Re: Turkey Point Unit 3  
Docket Nos. 50-250  
Subsequent Renewed License No. DPR-31  
Fifth Ten-Year Inservice Inspection Interval Revised Relief Request No. 6 and  
Supplemental Information for Train B CCW Return Piping

**REVISED RELIEF REQUEST No. 6**

**Turkey Point, Unit 3**  
**Fifth 10-Year Interval Revised Relief Request No. 6**  
**Component Cooling Water Welded Repairs for External Corrosion**  
**L-2020-073**

### **Supplemental Information on Train B CCW Return Piping**

Diagram 1:

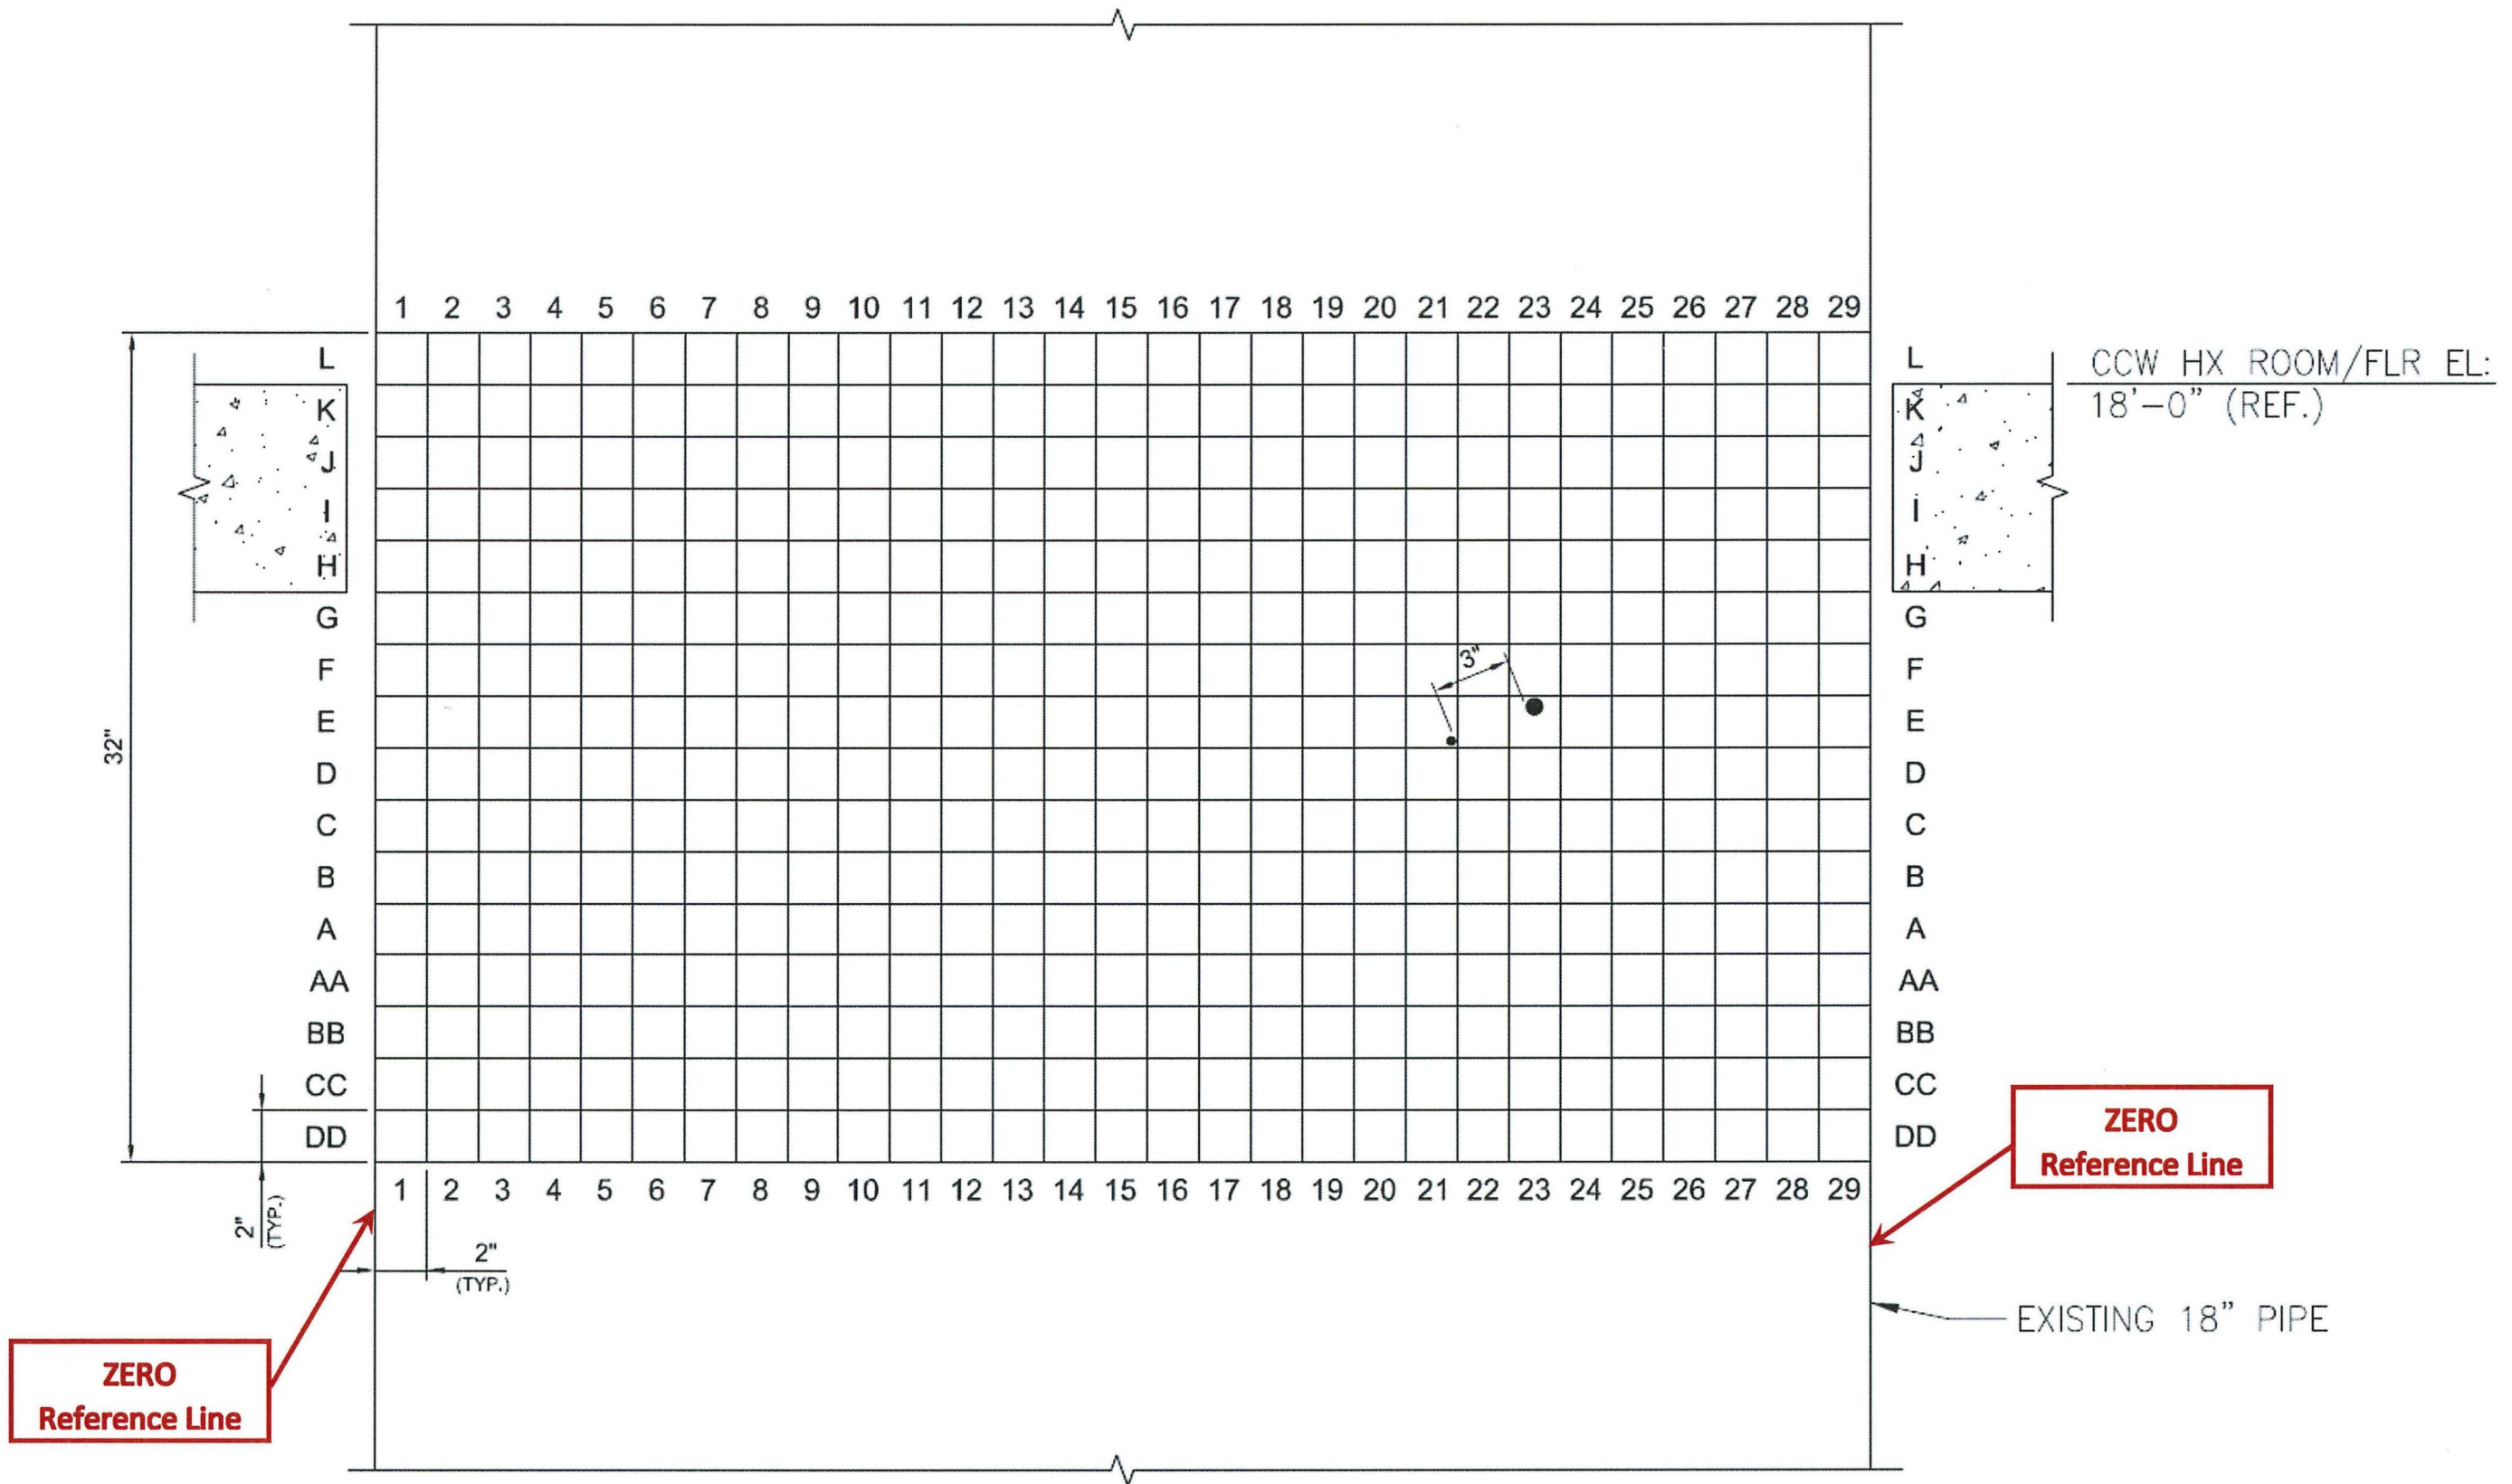
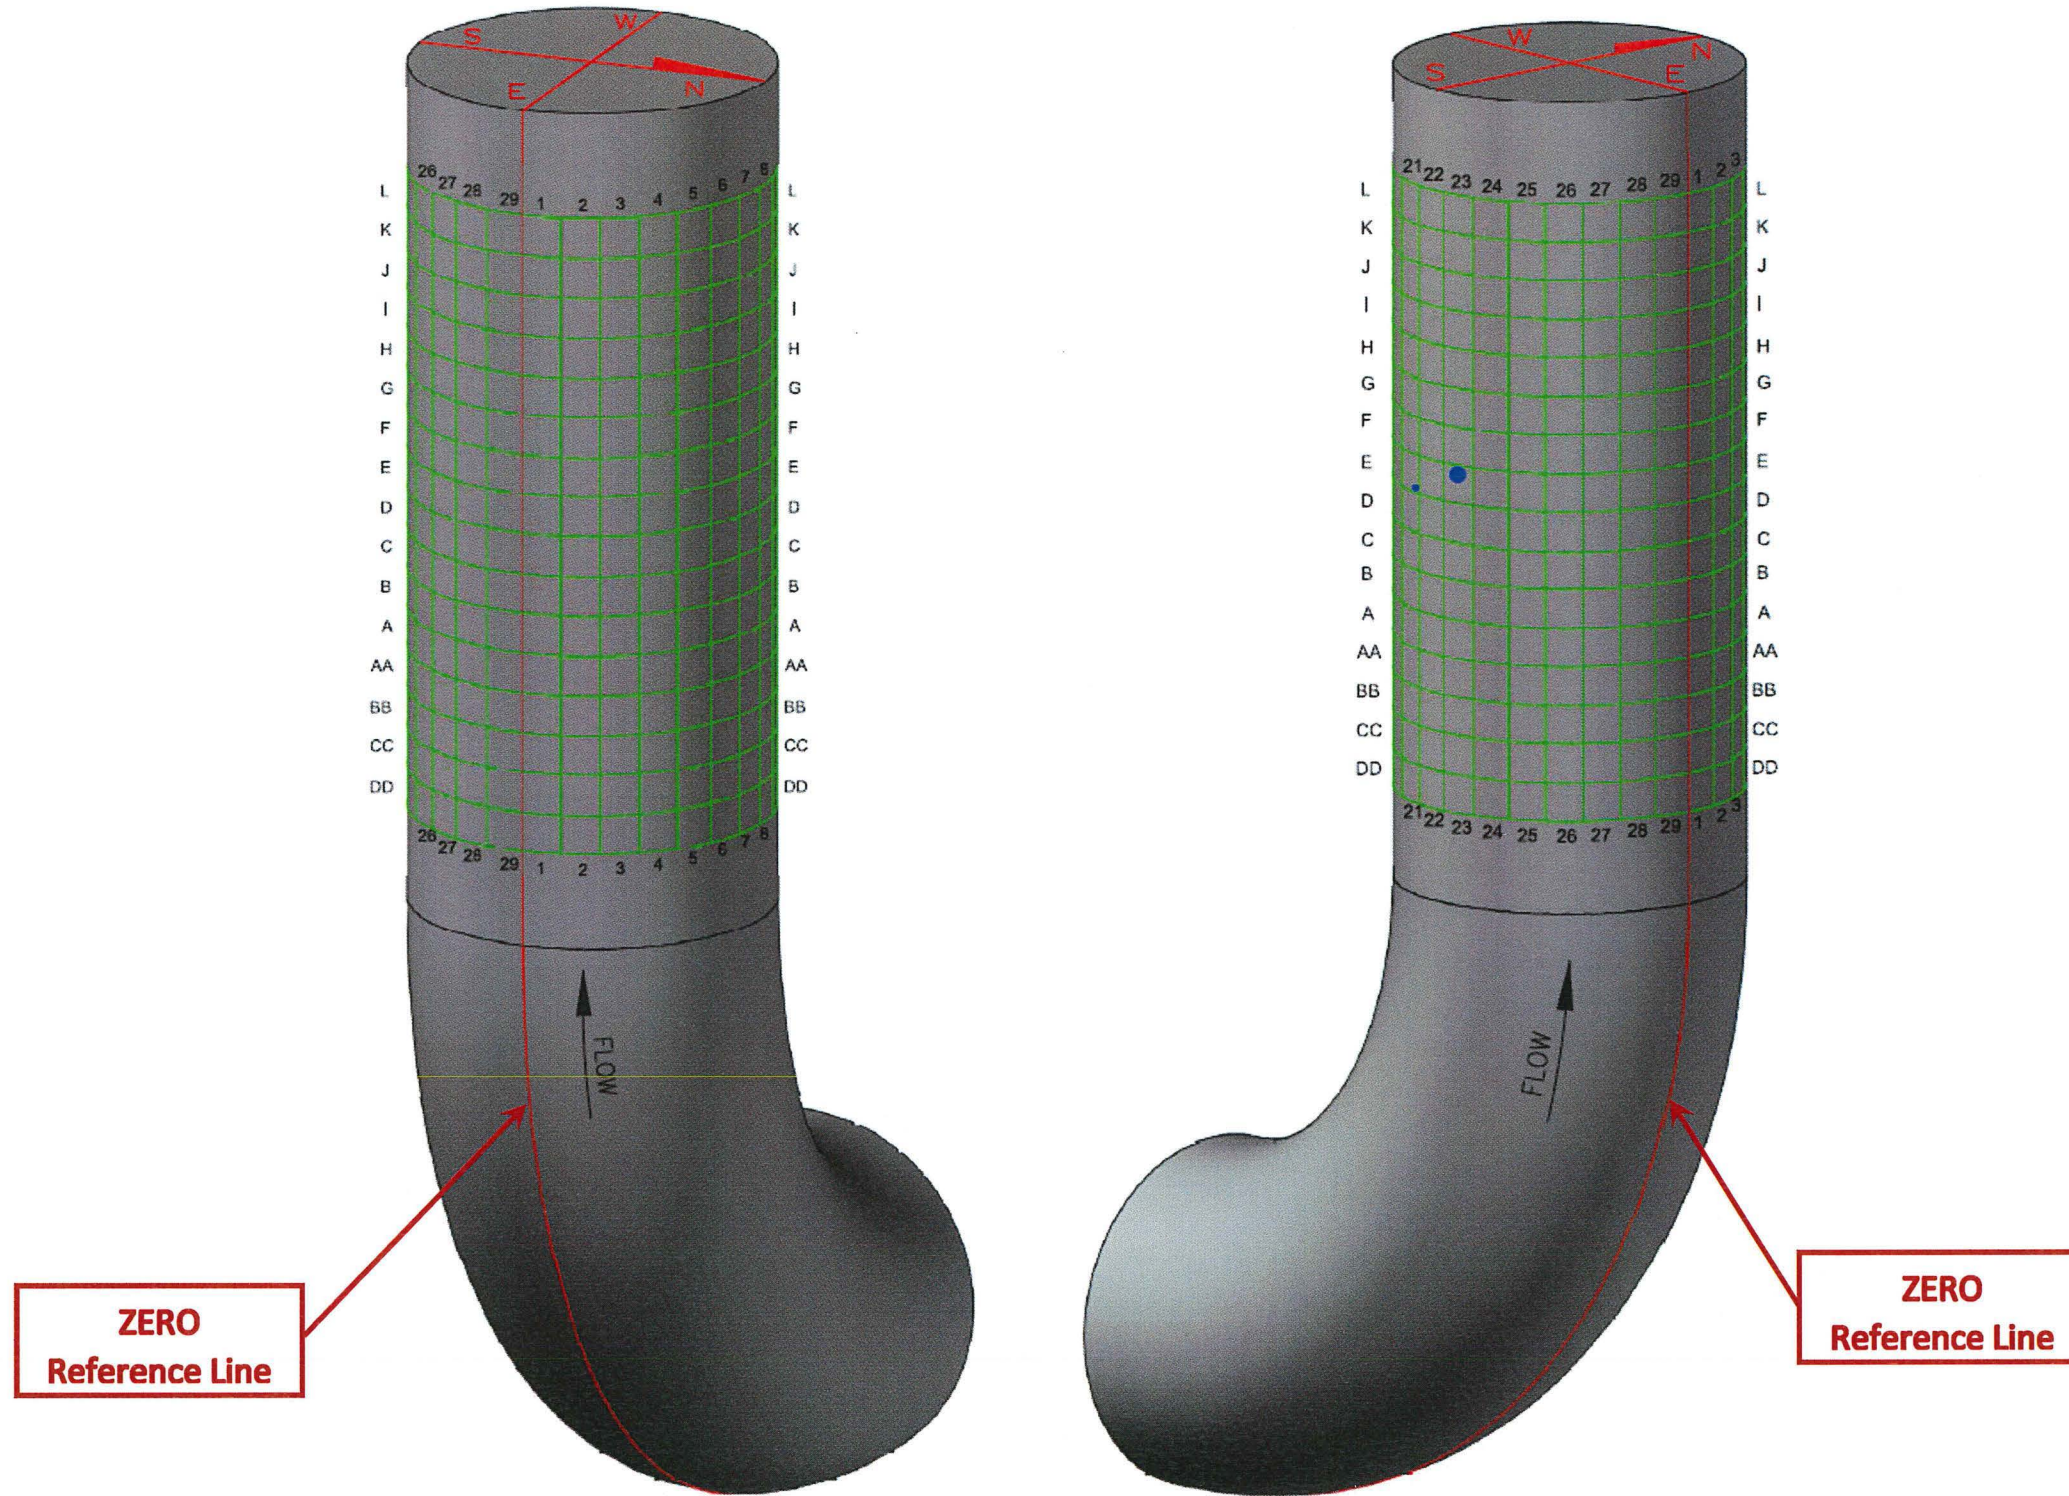
1. Provide a Map of as found pipe wall thickness and the NDE thickness profile as it applies to the total length of the PMCap
2. Drawing and design spec of the PMCap
3. Drawing showing placement of the PMCap overlaid on the pipe wall thickness
4. Weld details for the installation of the PMCap
5. NDE performed on PMCap Installation weld
6. Analysis of effect of the extra weight of the PMCap on supports
7. Future monitoring of the area
8. Justification for this being a permanent repair.

Map of as found pipe wall thickness and NDE report is enclosed in Attachment 2.

Grid was established on pipe in 2" x 2" blocks, with the extra-dose of the upstream elbow orienting the ZERO Reference Line (see Diagram 2) and labeled based upon direction of flow. Original inspection area: 360° circumferentially (1 through 29), and 24" longitudinally (A through L) ending 2" above the CCW HX Room floor (18' elevation). An additional 8" upstream (DD through AA) was added due to PM Cap alignment (see Diagram 1 & 3).

Grid location: E23 is the existing 5/8" diameter through-wall hole (Ref. AR 02350581), E21 is below screening value at 0.104", and G23 is lowest above screening at 0.109" (see Table 1). At each of these locations (E23, E21 and G23) readings were taken 1/2" on either side of the low point in both longitudinal and circumferential directions, and distances measured between where the material returns to at/above screening value (see Table 2).
